MINERALS PROGRAM INSPECTION REPORT
PHONE: (303) 866-3567

MINE NAME: Table Mountain Quarry	MINE/PROSPECTING ID#: M-1999-004	MINERAL: Silica (quartz, quartzite)	COUNTY: Fremont
INSPECTION TYPE: Monitoring	INSPECTOR(S): Timothy A. Cazier, Amy Eschberger	INSP. DATE: January 29, 2018	INSP. TIME: 11:45
OPERATOR: Tezak Heavy Equipment Co. Inc.	OPERATOR REPRESENTATIVE: Randy DiLuzio	TYPE OF OPERATION: 112c - Construction Regular Operation	
REASON FOR INSPECTION: Priority	BOND CALCULATION TYPE: Partial	BOND AMOUNT: \$202,793.00	
DATE OF COMPLAINT: NA	POST INSP. CONTACTS: Colo. Land Board	JOINT INSP. AGENCY: Colo. Land Board	
WEATHER: Clear	INSPECTOR'S SIGNATURE: 	SIGNATURE DATE: March 8, 2018 <u>Revised</u>

Photo 1. East highwall reclamation (looking east).

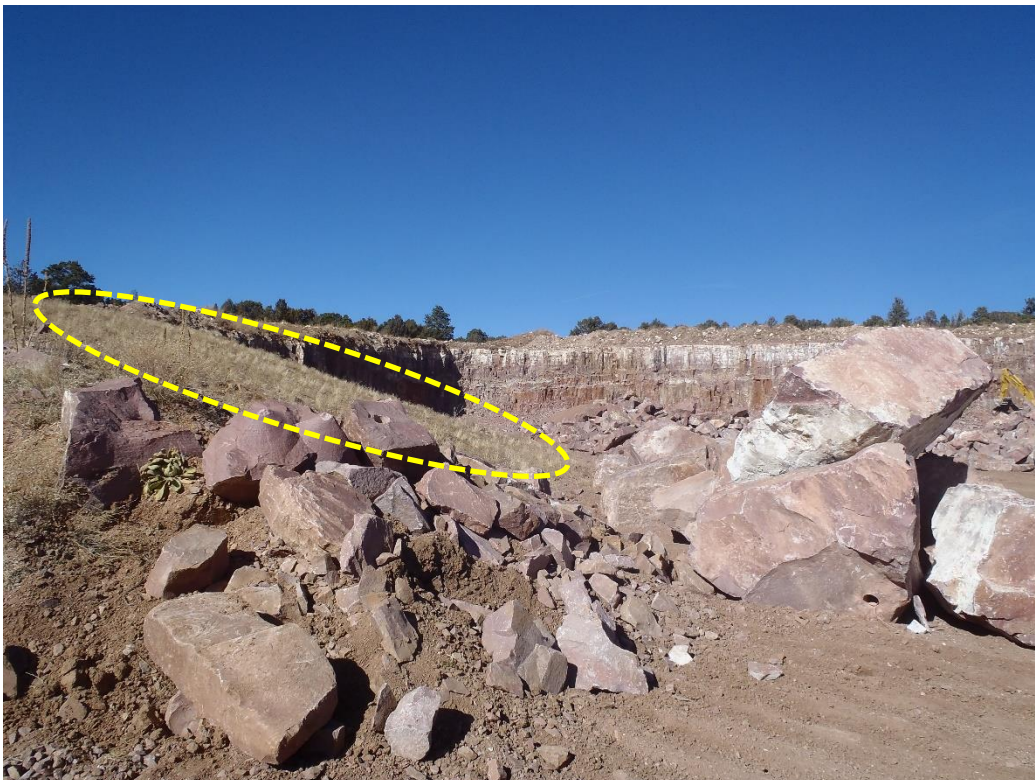
Revegetation: Revegetation had been initiated at both ends of the highwall in the backfilled areas of the highwall (see **Photos 1 and 2**). No noxious weeds were observed.

M-1999-004 1/29/2018 Post Inspection Map

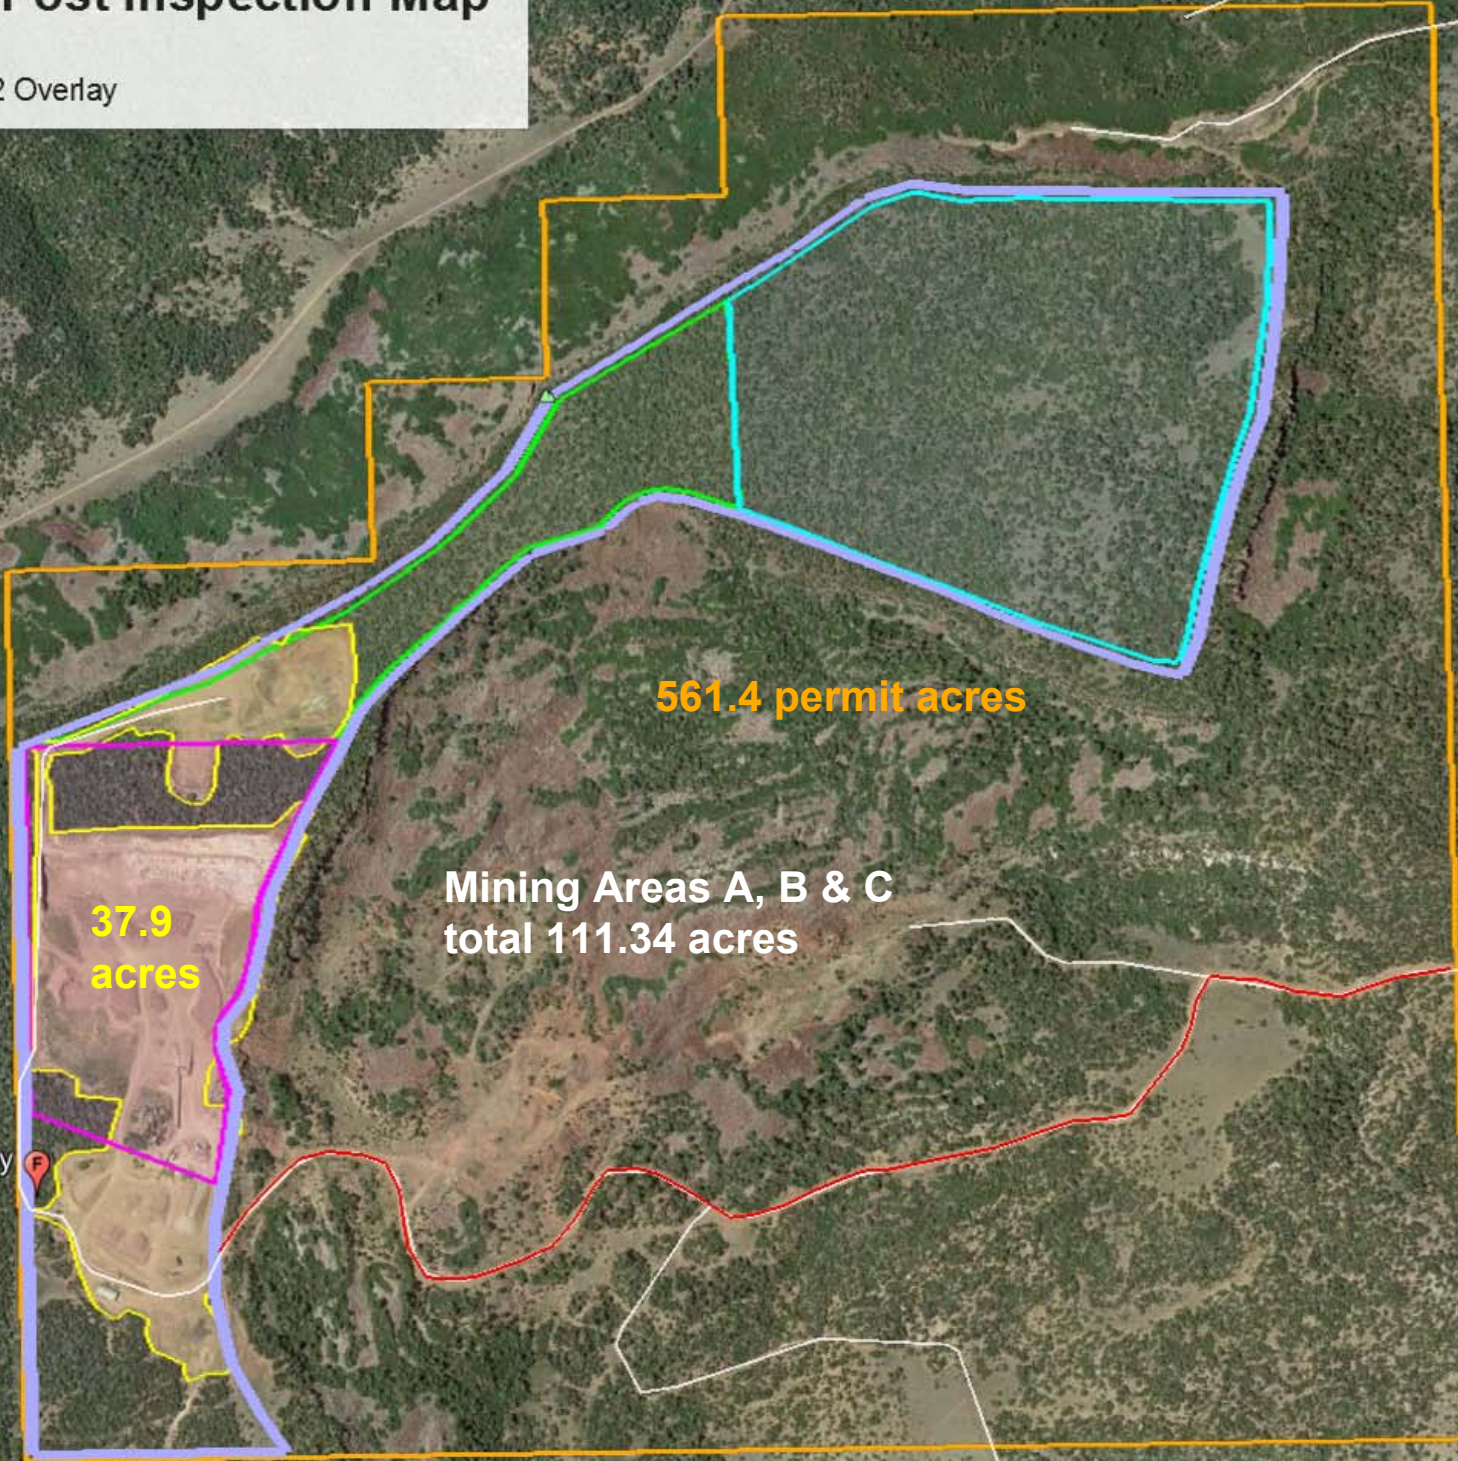
Gen. Compliance with Mine Plan: The operation appeared to be in compliance with the approved mine plan. Google Earth was used to measure the disturbed area, which was estimated to be just under 38 acres (see **enclosed** post-inspection map). This is near the limit of the permit's maximum allowed disturbed area at one time. Based on the amendment 1 (AM-01) application and subsequent adequacy reviews, it appears the maximum allowed disturbed area at any given time is 38.2 acres. The concurrent reclamation on the south end of the east and west highwalls in Area A (see **Photos 1** and **2**) might offset the disturbed area total if a release were requested. The Permittee should consider a revision to the permit, or requesting releases of reclaimed areas so the affected area does not exceed the current maximum allowed area of 38.2 acres.
